Economic Commission for Europe**Inland Transport Committee****World Forum for Harmonization of Vehicle Regulations****Working Party on Lighting and Light-Signalling****Eighty-third session**

Other UN Regulations:**UN Regulation No. 86 (Installation of lighting and light-signalling devices for agricultural vehicles)****Revised proposal for a draft amendment to UN Regulation No. 86****Submitted by the experts from the European Agricultural Machinery Association***

The text reproduced below was prepared by the experts from the European Agricultural Machinery Association (CEMA) with the aim to improve lateral lighting on vehicles of more than 4,6 m and to take into account asymmetric vehicles designs. It intends also to provide some editorial corrections and to harmonize some requirements with UN Regulation No. 48. The modifications to the current text of the Regulation are marked in bold for new or strikethrough for deleted characters. Following the request of the Working Party on Lighting and Light-Signalling at its eighty-third session in October 2020, the original proposal in ECE/TRANS/WP.29/GRE/2020/7 has been complemented with a new clause on transitional provisions, because th

Figure 1

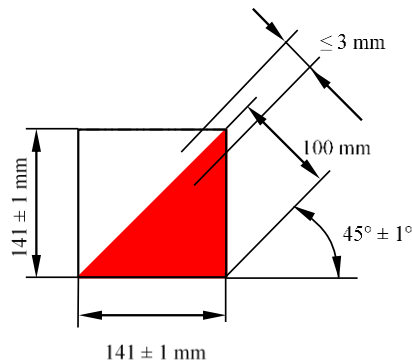
Paragraph 1.1, amend to read:

"1.1. Signalling panels and signalling foils shall have the following dimensions:"

Figure 2

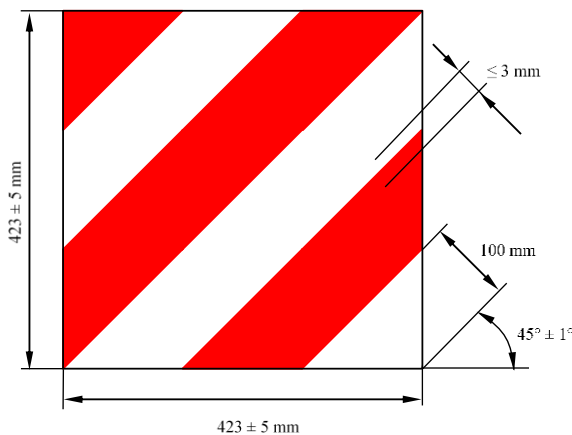
Annex 6,

Paragraph 1.1, Table 1, amend to read:

Deviations from the specified formats are permitted, provided that:

- (a) The visible surface of each panel or foil shall be at least equal to 4 basic standard areas and
- (b) Each panel or foil shall comprise at least 3 entire basic standard areas.

If the structure, design or the operational use of the vehicle makes it impossible to comply with such a requirement, each panel or foil may be split into 2 parts as long as each part comprises at least 2 entire basic standard areas."
